# January 2022 Med Tips

# *SERVICE BULLETIN*

**MODEL:** Eclipse 5 Oxygen Concentrators

**ISSUE:** IEC 80601-2-69 Oxygen Concentrator Particular Standard Compliance

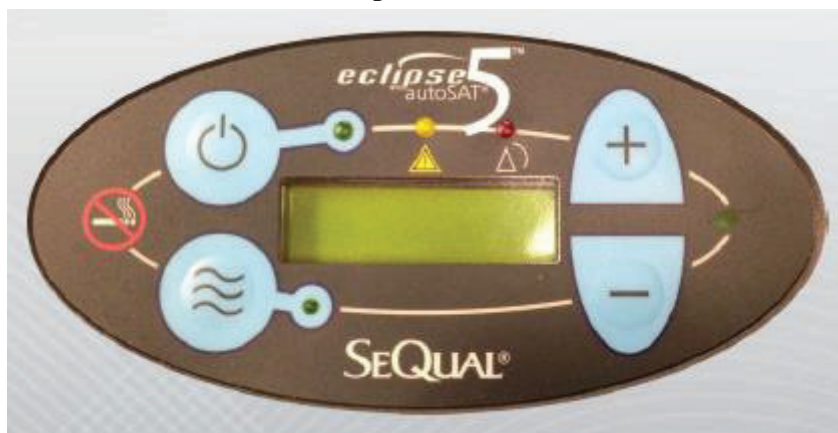
**NOTES:** To ensure Eclipse devices are compliant with the IEC 80601-2-69 (including IEC 60601-1 edition 3.1 and EMC IEC 60601-1-2 4th edition), coming in 2018 the Eclipse 5 will no longer have a red alarm indication. This change will be accompanied by a revised touch panel, new circuit board part number, and an updated alarm code troubleshooting tables.

The Eclipse 5, including the AC power supply, will be IEC 60529 IP22 compliant rather than IPX1. The AC power supply will be changed to a two pronged cord type, Type II power supply. IEC 60601-1 applied part classification for the device changes from Type B to Type BF. The older Eclipse 5 units can use the new power supply. In order for the new Eclipse 5 to be used with the old power supply, the CSA labeling would need be removed from the unit. The applied part would then change from type BF to type B.

## Updated Eclipse 5 Touch Panel

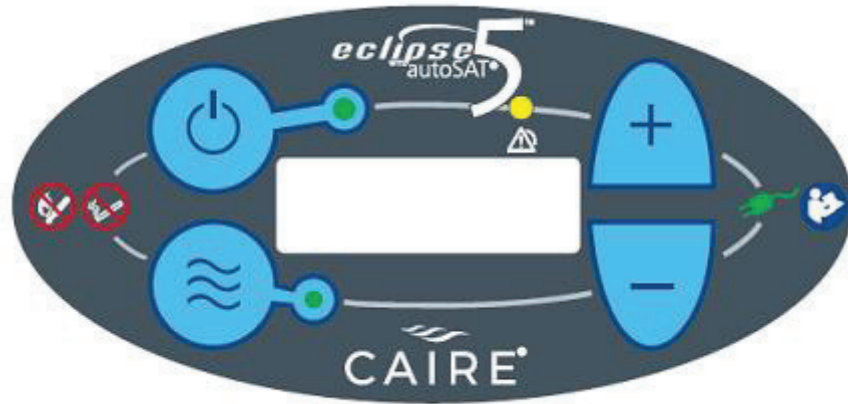
With the new display panel, there will no longer be a red indication for an alarm code. The new panel will display a yellow LED, audible alarm, and an associated fault code.
